FLA COE FLB COE FLD Conventional Business Class FLC 112 Conventional Century Class Conventional Argosy COE Cargo Columbia 122SD and Coronado > Business Class M2 Cascadia > 108SD/114SD New Cascadia Freightliner Service Bulletin

Description of Revisions: This bulletin replaces the version dated 10/31/2019. The build date section has been added.

Powertrain PDM and Main PDM Bracket Modification

Fig. 4, New Powertrain Power Distribution Module (PTPDM) Bracket Installation

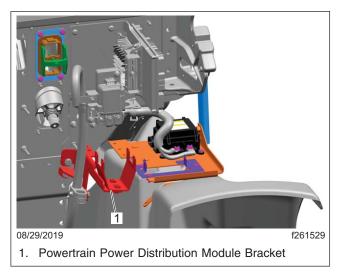
7. Attach the PTPDM bracket on the cab using the previously removed bolts. Tighten the bolts 33 lbf⋅ft (44 N⋅m). See **Fig. 4**.

Fig. 5, Powertrain Power Distribution Module (PTPDM) Wiring Harness

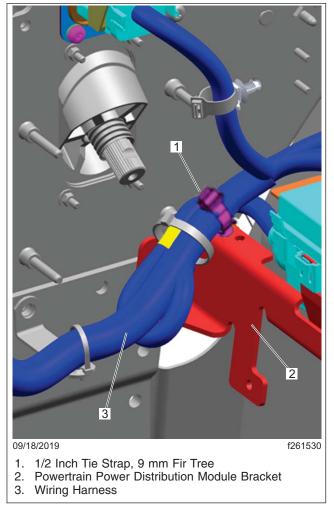
8. Position the PTPDM wiring harness, as needed, so that it exits the PTPDM housing horizontally, see **Fig. 5**. Position the rubber grommet back into PTPDM housing.

Fig. 7, Checking for Clearance

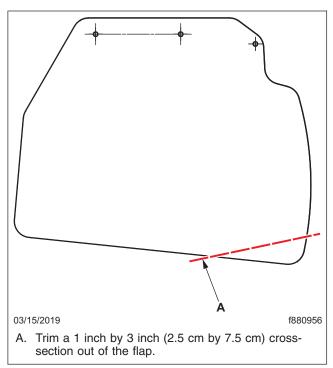
13. Close the hood and check for proper clearance between PTPDM and flap. If there is insufficient clearance, trim a 1 inch by 3 inch (2.5 cm by 7.5 cm) cross-section out of the flap. See **Fig. 7**.
